**GOVERNMENT OF THE DISTRICT OF COLUMBIA
DEPARTMENT OF CONSUMER AND REGULATORY AFFAIRS
OFFICE OF THE ZONING ADMINISTRATOR**

Re: 1421 Florida Avenue NW (Square 2660, Lot 237 "Subject Property")

This letter responds to your request regarding a proposed project at the subject property referenced above, and memorializes the substance of the preliminary design review meeting (PDRM) of May 4, 2010 in respect of same.

SK-ZNC

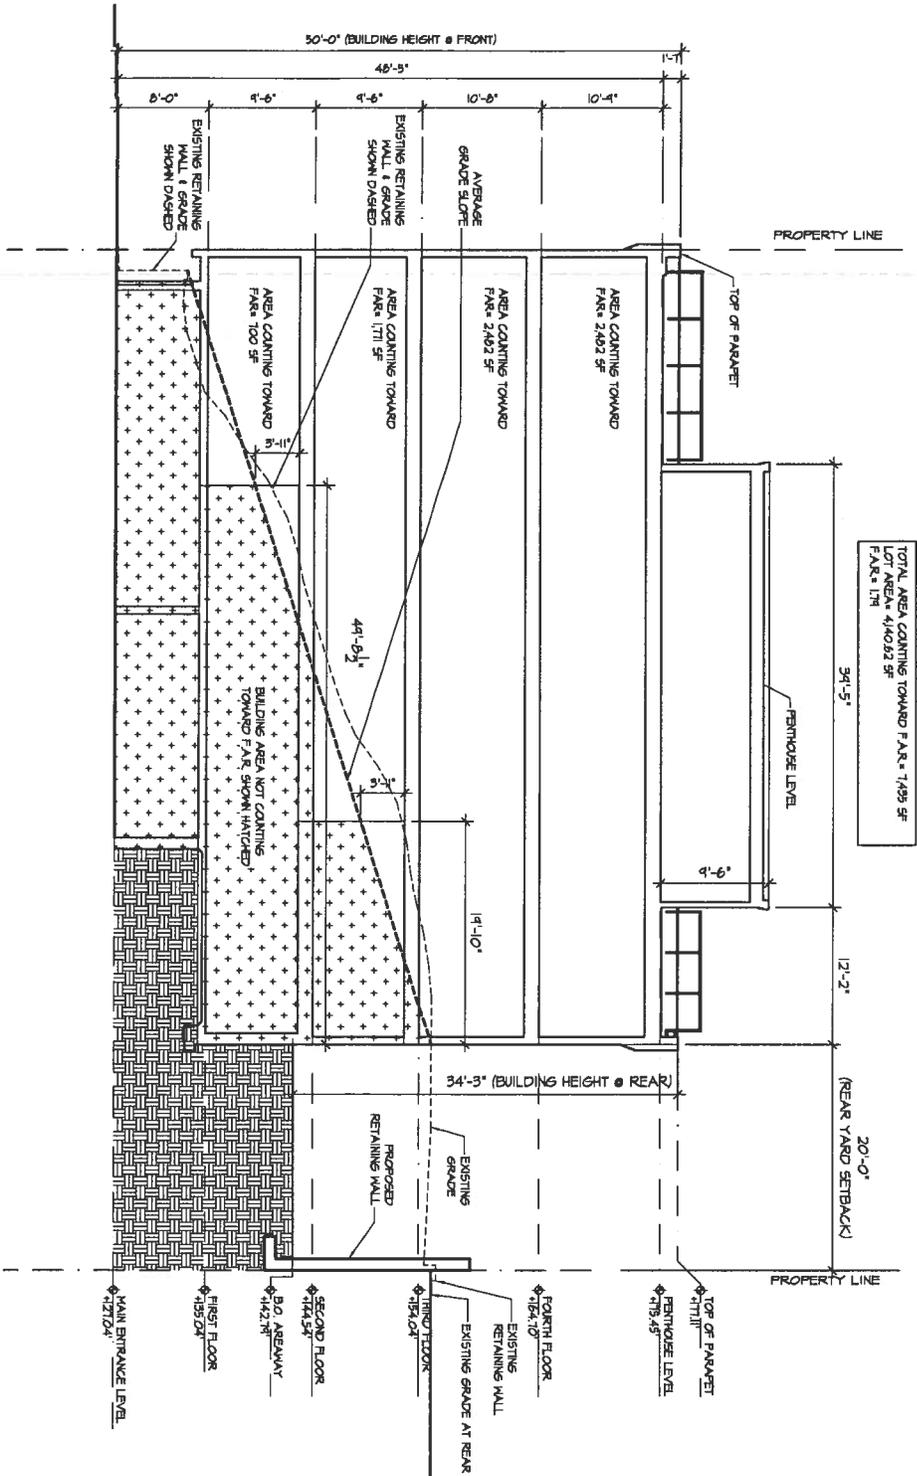
After reviewing your submitted section drawing labeled SK-ZNG, dated 6/6/11, I conclude that the drawing accurately depicts the use of the Grade Plane Method, and the shaded areas may be deemed as a cellar and excluded from the FAR calculation. If the resultant floor area contains 7,435 square feet of gross floor area (1.79 F.A.R.), this is less than the maximum 1.8 FAR and would comply.

As depicted in the provided section labeled SK-ZNG, the height at the middle of the rear of the proposed structure as measured from mean finished grade, based on the drastic change in topographical elevation, to the highest point of the main roof or parapet is thirty-four feet and three inch (34 ft- 3 inches) which results in a minimum rear yard setback requirement of eleven feet and five inches (11 ft- 5 inches) (height at mean finished grade x 4 inches = 137 inches ÷ 12 = 11.41ft). Therefore the 15 foot rear yard standard applies.

SK-Z1

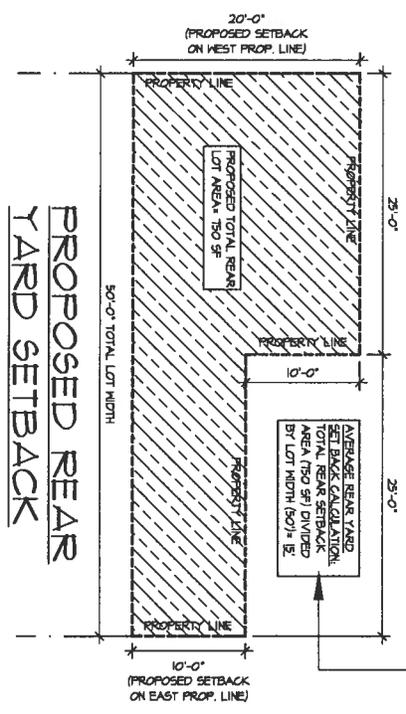
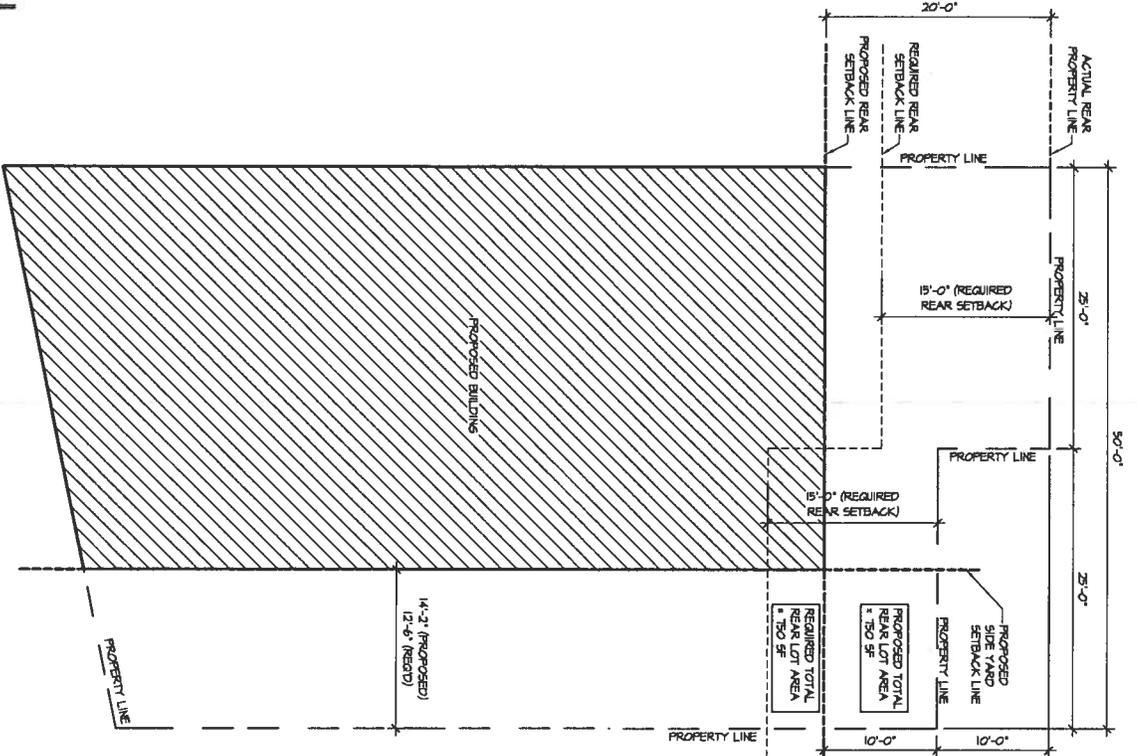
Total square feet in area of portion of lot behind a line drawn at the farthest point of the rear building line parallel to the rear property lot line, divided by the linear distance of the line so drawn at the points at which the line intersects the two side property lot lines; consistent with the graphic and numerical illustration attached as drawing SK-Z1.

Based on this drawing and applicable calculations, I have determined that the proposed depicted rear yard setback complies.
